#### REMARKS

Appl. No. 10/695,702  
Amdt. Dated September 29, 2004  
Reply to Office Action of July 23, 2004

INVENTOR Peter F. Gerhardinger  
TITLE Vacuum Insulated Quartz...  
SN: 10/695,702 Sheet 2 of 3

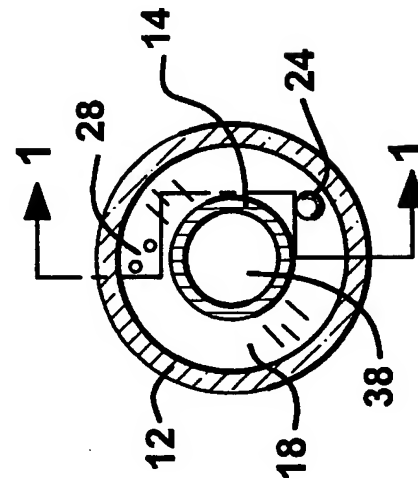
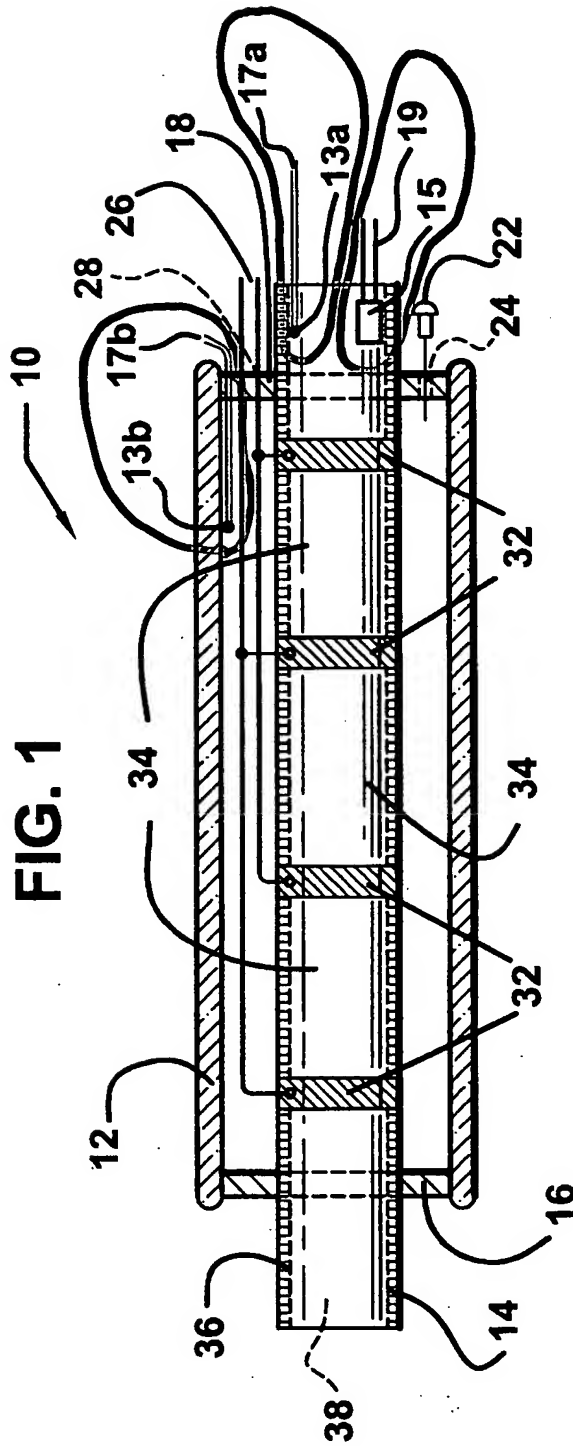
The Examiner has objected to the drawings under 37 C.F.R. 1.83(a), wherein the drawings must show every feature of the invention specified in the claims. The Examiner asserts that the non-tubular inner member of claim 27, the temperature sensors of claims 28 and 29, and

the flow switch of claim 30 must be shown or the features(s) canceled from the claim(s). No new matter should be entered.

In response to these objections, the applicants have amended Fig. 1 to include the temperature sensors 13a and 13b, respectively, of claims 28 and 29, and the flow switch 15 of claim 30. These amendments find support, for example, at page 10, lines 7-13, as originally filed. In addition, the applicants have added Figs. 3 and 4 to show the non-tubular inner member

The attached sheets of drawings include changes to Fig. 1, which adds a temperature sensor 13a with its associated conduction means 17a in the fluid stream, a temperature sensor 13b with its associated conduction means 17b that is attached to a wall of the outer quartz glass tube 12, and a flow switch 15 with its associated conduction means 19 in the fluid flow. Also, Figs. 3 and 4 have been added to show a non-tubular inner member 14' embodiment.
